QUALITY ASSURANCE -- NON-CONFORMANCE REPORT

Report No: NCR-000536

Reference Description: Excessive Root Opening at the Floor Beam Flange to the Top Flange of the Longitudinal Diaphragm for Segment 6BW

Job Name: SAS Superstructure
Document No: 05.03.06-000497

WELD NUMBER: **SEG029B-009**

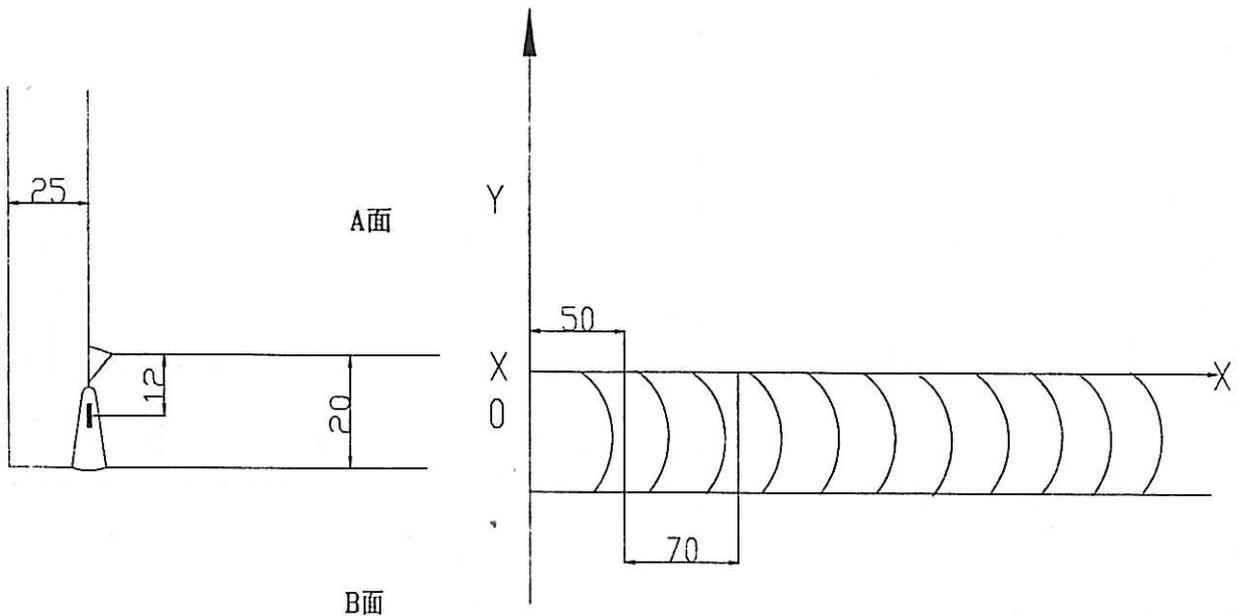
Description of welding discontinuity:

Rejected indication found by ultrasonic inspection is less than the maximum allowance aggregate length.

(UT探伤发现的缺陷总长度小于最大允许长度。) SEG029B-009

1. 从缺陷距离端面较近一侧 ($D \leq 0.65T$, D 为缺陷深度, T 为板厚) 采用碳刨或打磨的方法去除焊缝缺陷;
 2. 参照返修焊接工艺规程 (WPS) 准备正确的接头型式, 预热和焊接;
 3. 焊前对修补区域进行VT检测保证缺陷完全被消除;
 4. 将修补区域打磨到与母材或邻近焊缝平齐;
 5. 对焊缝进行UT检测, 检测范围为返修区域以及其两端各延长50mm.
-
1. Gouge or grind from nearer side from metal edge ($D \leq 0.65T$, "D" is depth of defects, "T" is thickness of metal) to remove all defects;
 2. Follow repair WPS for joint preparation, preheat, and weld deposit;
 3. Verify with VT no defects remain in the weld joint prior to welding;
 4. Grind the repaired area flush with base metal or the adjacent weld;
 5. Perform UT inspection to the weld along with 50mm on each end of the repair area;
